Adding a Simple Package Model to the Channel Response

In support of comment 36, 129, 132 resolution

Comparison for 12 mm line between math estimated and circuit model

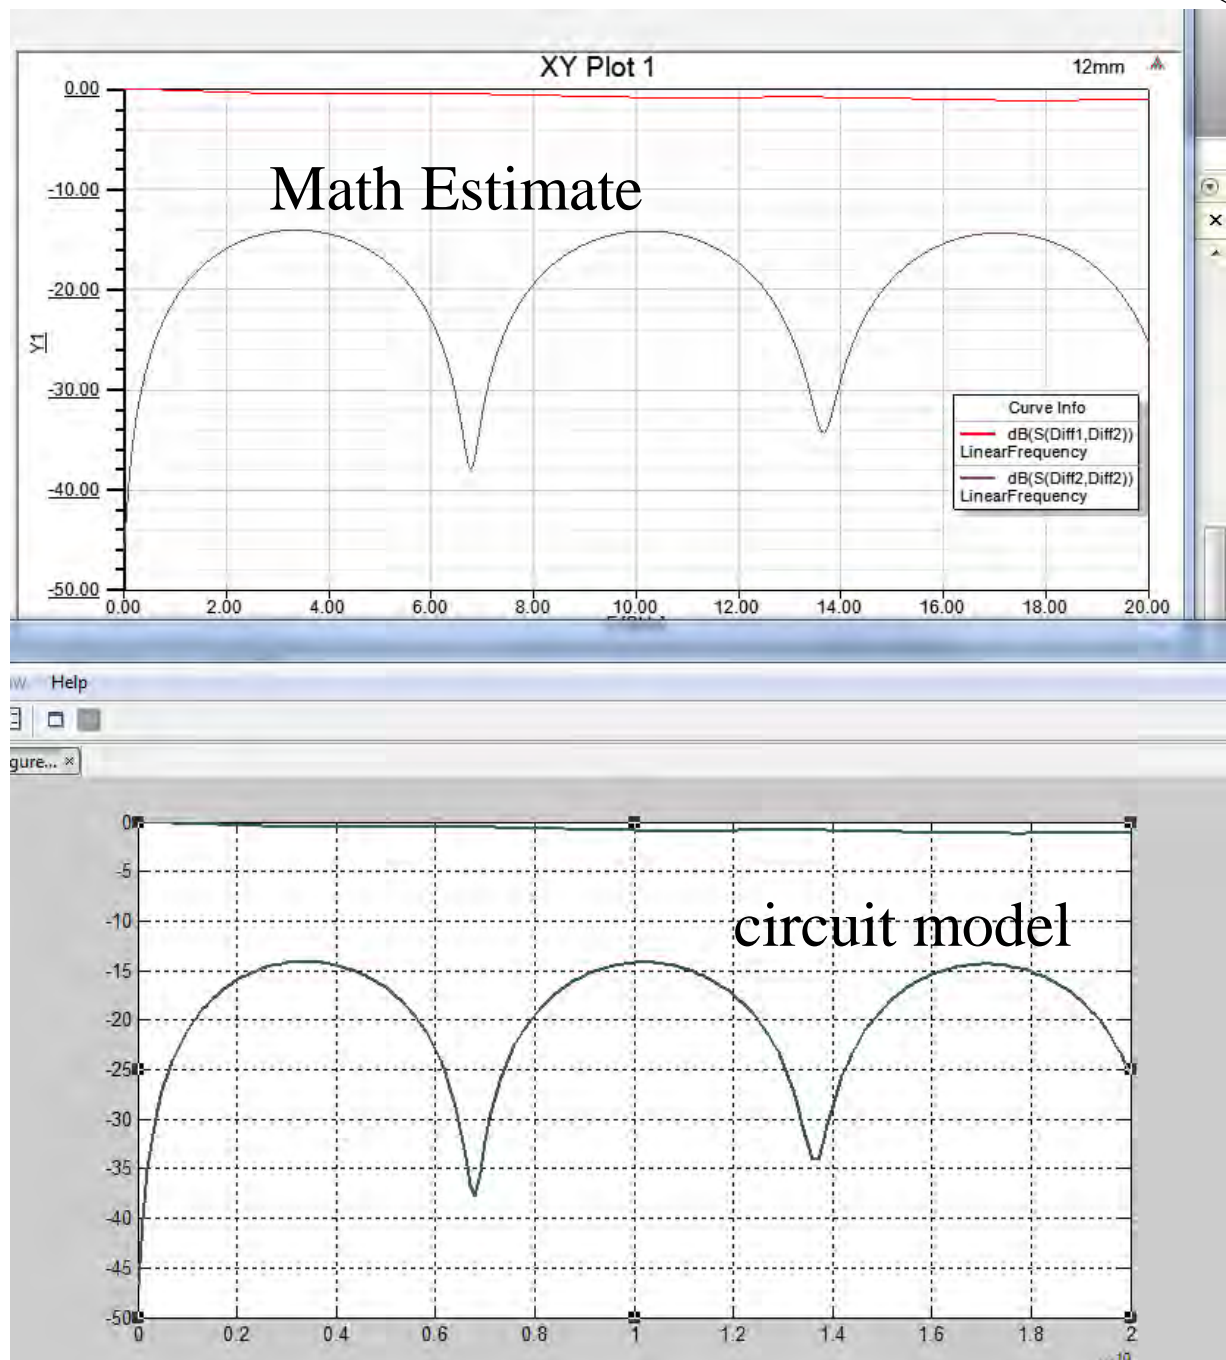
Estimate differential s-parameters for a small segment of uniform lossy transmission line (replaces 93A.1.2)

- Segment can be either solved or measured.
- Recommend: 1mm package transmission line s4p file
- Fit RL and IL using clause 93A.2
 - Find a_{il} and a_{rl} from S11 and s21
 - Determine γ_{IL} and γ_{RL}
 - Where $\gamma_x = a_0 + a_1 \cdot \sqrt{f} + a_2 \cdot f + a_4 \cdot f^2$
 - This form is from clause 93A.2, eq. (93A-31)
- For the transmission line
- $s_{11tline} = e^{\gamma_{RL}} \left[\sum_{n=1}^{segments} e^{\gamma_{IL} \cdot (2 \cdot n - 2)} \right]$
- $s_{21tline} = e^{\gamma_{IL} \cdot segments}$
- i.e. $[S_{tline}]$
- The package transmission line is defined by 9 parameters in a table in 93a.1.2
 - $a_{il}(0, 1, 2, 4)$, $a_{rl}(0, 1, 2, 4)$, number of segments (Pkg_length in mm)

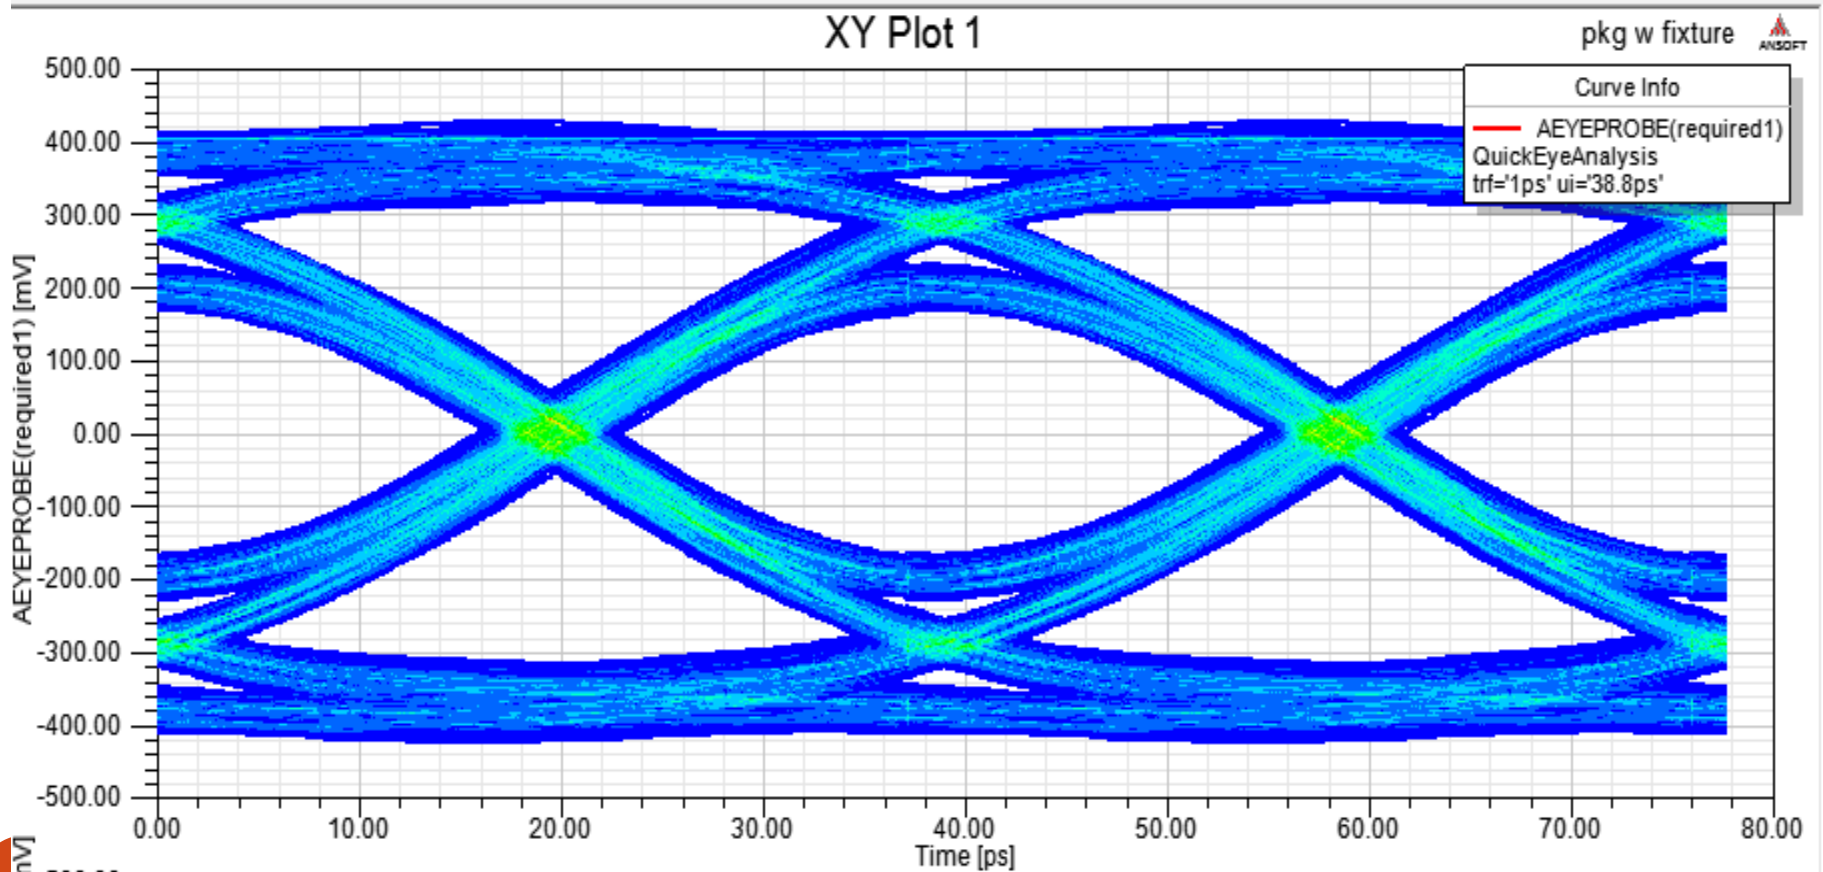
25Gbps NRZ eye diagram at tp0a suggests removing transmitter filter from COM is OK because the package and die load limits transition time
